Item Name: AS350/AS355 Quick Release Basket Strut Retrofit

DART SERVICE INSTRUCTION

TO AMEND INSTALLATION INSTRUCTIONS D350-607-3 Rev.D,
INSTALLATION INSTRUCTIONS D350-607-4 Rev. C AND
INSTRUCTIONS FOR CONTINUED AIRWORTHINESS ICA-D350-607 REV. 6
REF TCCA STC: SH94-14
REF FAA STC: SR00213NY
REF EASA STC: EASA.10016996
REF BRAZILIAN STC: 2007S03-03/-04/-05/-06

A	NEW ISSUE	AJS	14.05.16
REV.	DESCRIPTION	BY	DATE
DESIGN	AJS	DART AEROSPACE LTD HAWKESBURY, ONTARIO, CANADA	
DRAWN	AJS		
CHECKED	N/A	DRAWING NO.	REV. A
MFG. APPR.	N/A	DSI 9699	SHEET 1 OF 2
APPROVED		TITLE	SCALE
DE APPR.		LUG REPLACEMENT	NTS
DATE	14.05.16	COPYRIGHT © 2014 BY DART AEROSPACE LTD THIS DOCUMENT IS PRIVATE AND CONFIDENTIAL AND IS SUPPLIED ON THE EXPRESS CONDITION THAT IT IS NOT TO BE USED FOR ANY PURPOSE OR COPIED OR COMMUNICATED TO ANY OTHER PERSON WITHOUT WRITTEN PERMISSION FROM DART AEROSPACE LTD.

FIGURE 1: INSTALLATION OF D4775-041 FWD STRUT

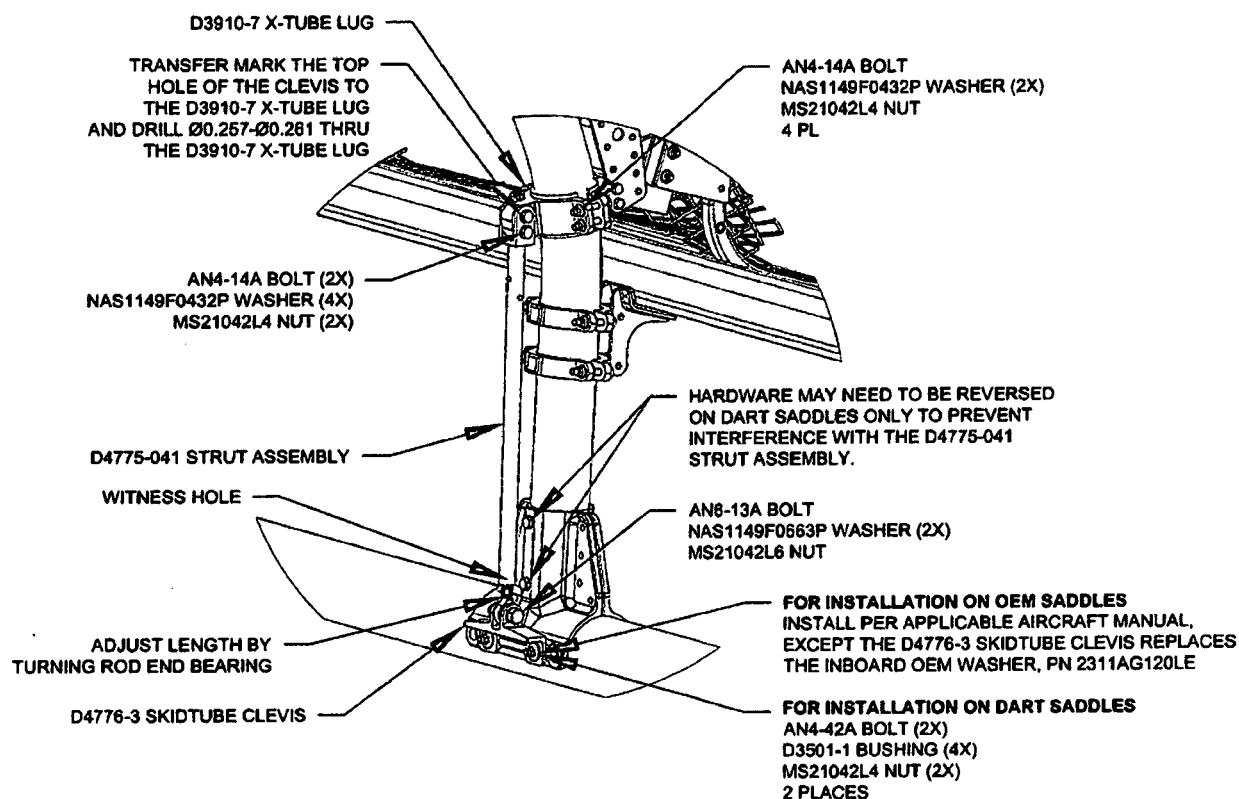
- 3.1 Substitute the Forward Lower D3910-5 X-Tube Lug with the D3910-7 X-Tube Lug as shown in Figure 1.
- 3.2 Install the forward D4775-041 Strut Assembly. Transfer mark from the upper hole on the clevis of the D4775-041 Strut Assembly to the D3910-7 X-tube Lug and drill thru the lug $\varnothing 0.257$ - $\varnothing 0.261$ as shown in Figure 1. Touch up chemical conversion coating per MIL-DTL-5541. Check the witness holes located at the bottom end of the D4775-041 Strut Assemblies to ensure that the thread from the rod end extends past the witness hole.
Torque MS21042L4/-4 nuts to 50-70 in-lbs (5.7-7.9 N-m). Torque MS21042L6/-6 nuts to 160-190 in-lbs (18.1-21.5 N-m).
- 3.3 Complete the installation in accordance with Installation Instructions D350-607-3 Rev. D or D350-607-4 Rev. C.
